PERFORMANCE SPECIFICATION SHEET

SWITCHES, THERMOSTATIC, (BIMETALLIC), TYPE I,
HERMETICALLY SEALED, SINGLE POLE, SINGLE THROW
(SPST), 1 AMPEREAND LOW LEVEL

This amendment forms a part of MIL-PRF-24236/13G, dated 22 January 2001, and is approved for use by all Departments and Agencies of the Department of Defense.

CONFIGURATION 2

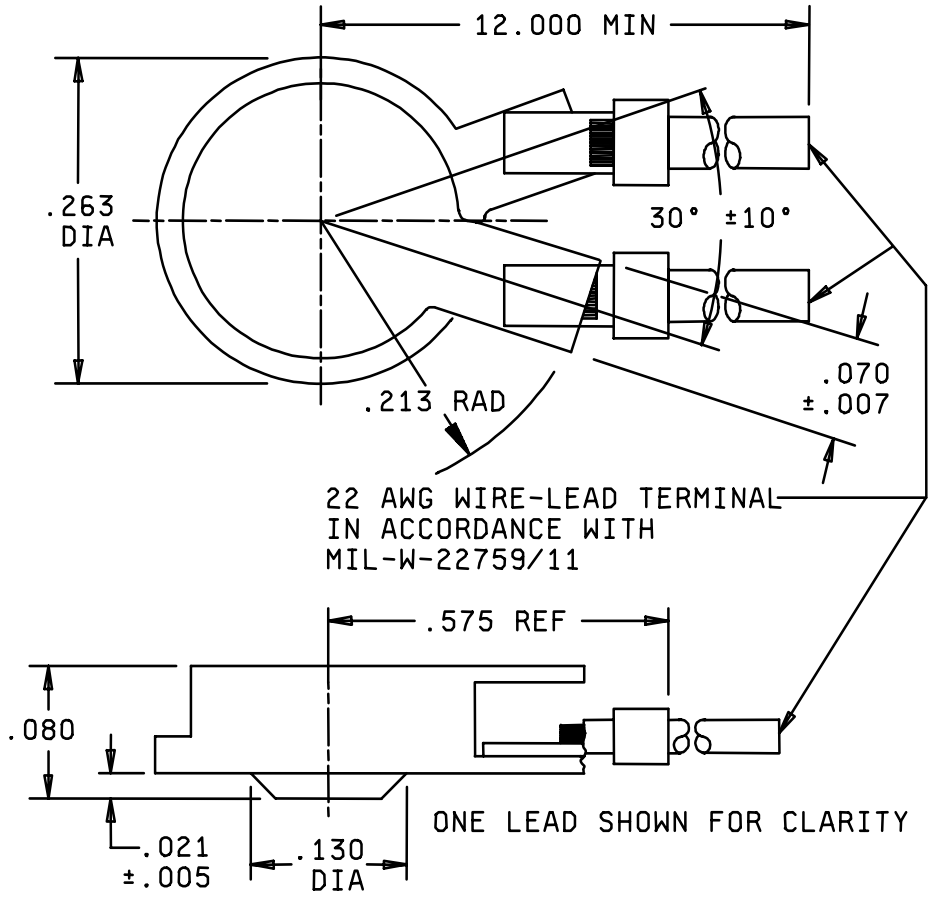
Figure 1, Delete Configuration 2 and replace with the following.
